#### ENVIRONMENTAL PROTECTION AGENCY

40 CFR Part 63

National Emission Standards for Hazardous Air Pollutants for Source Categories: Organic Hazardous Air Pollutants From the Synthetic Organic Chemical Manufacturing Industry and Other Processes Subject to the Negotiated Regulation for Equipment Leaks; Correction

**AGENCY:** Environmental Protection Agency (EPA). **ACTION:** Final rule; Correcting amendments.

Figure 7. Compliance Options for Control of Table 9 HAP's (Refer to §63.138(c))

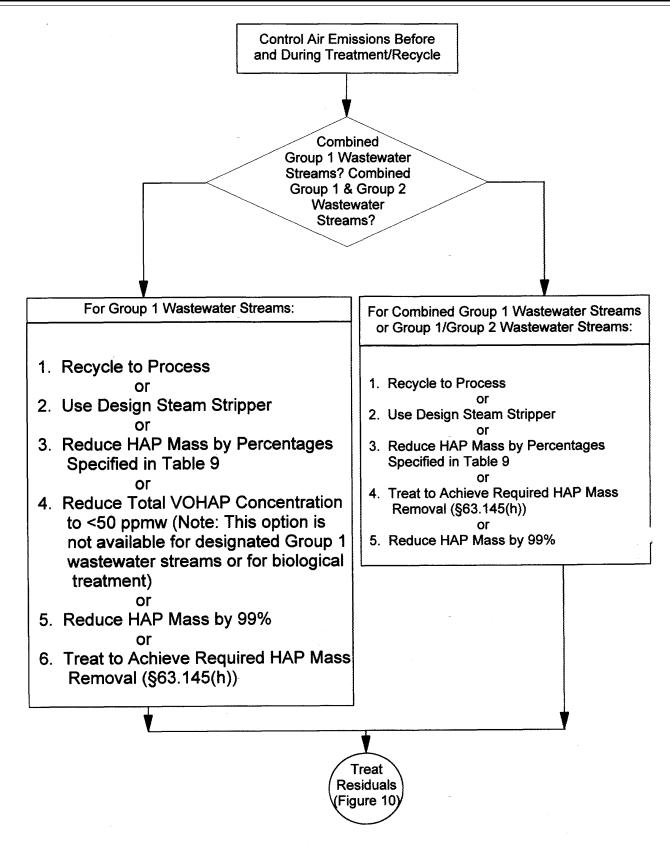
Various sections in subpart G are being revised to correct drafting errors in the usage of terms and in crossreferencing. Several typographical errors in Figure 7, table 6, the definition of "incinerator" in § 63.111, and in §§ 63.144, 63.145, and 63.152 are being corrected. Various cross-referencing errors in table 15a, table 15b, the definition of "average flow rate" in § 63.111, and in §§ 63.138, 63.147, 63.150, and 63.175 are being corrected.

23. Figure 7 in the appendix to subpart G is revised to read as follows:
